ADDENDUM NO. 2

DATE: June 27, 2016

Contract 15-C-00021; Howard F. Curren AWTP HPO Gearbox/Mixer Upgrades and Piping Replacement

JACINTO CARLOS FERRAS, P.E., #49454 DESIGN DIVISION HEAD WASTEWATER DEPARTMENT	No.	DATE	REVISIONS	DES: VT DRN: JHJ CKD: JF DATE: 5/2/16	CITY of TAMPA WASTEWATER DEPARTMENT	HFC AWTP HFO GEARBOX / MIXER UPGRADES AND PIPING REPLACEMENT SECTION VIEW	1000417
	3						SHEET
	2						7
	▲	6/22/16	ADD LABEL

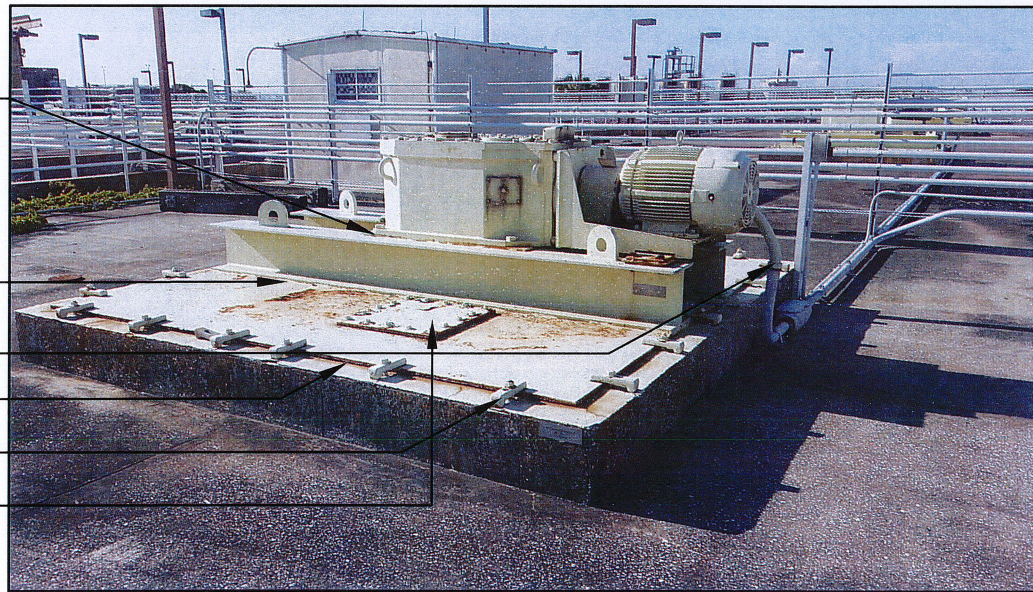
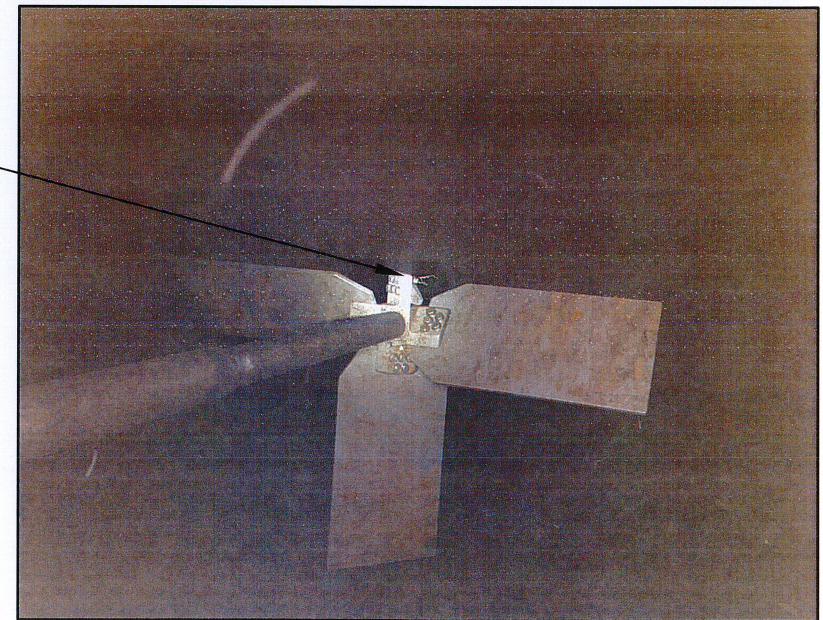
Item 2: Replace plan sheet 7 with the attached plan sheet 7.

- 1 THE MIXER DRIVE GEARBOX SHALL BE DESIGNED TO MOUNT ON THE EXISTING I-BEAM BASE STRUCTURE WITHOUT MODIFICATIONS TO THE I-BEAM STRUCTURE. MODIFICATIONS OF THE EXISTING I-BEAM STRUCTURE SHALL NOT BE ALLOWED. HOWEVER, DRILLING OF NEW MOUNTING HOLES IN THE I-BEAM STRUCTURE TO ACCEPT THE NEW MIXER DRIVE WILL BE ALLOWED IF THEY DO NOT COMPROMISE STRUCTURAL INTEGRITY.
- 2 PAINT EXISTING W12 x 72 BEAMS (2), HOLD DOWN CLIPS AND NEW STEEL PLATE. (SEE SPECS)
- 3 CONNECT NEW MOTOR TO EXISTING ELECTRICAL CONDUIT.
- 4 INSTALL AIR TIGHT SEAL GASKET BETWEEN PROPOSED STEEL PLATE AND CONCRETE.
- 5 REUSE EXISTING HOLD DOWN CLIPS
- 6 PROPOSED INSPECTION HATCH

- 7 CONTRACTOR SHALL INSTALL NEW IMPELLER BLADES AND HUBS IF EXISTING BLADES AND HUBS ARE MISSING OR DAMAGED. THE CITY WILL FURNISH THE NEW IMPELLER BLADES AND HUBS FOR INSTALLATION. CONTRACTOR SHALL PROVIDE ALL STAINLESS STEEL HARDWARE TO MATCH EXISTING. EXACT QUANTITY OF BLADES TO BE REPLACED IS UNKNOWN BUT SHOULD NOT EXCEED A TOTAL OF 5 IMPELLER BLADES.
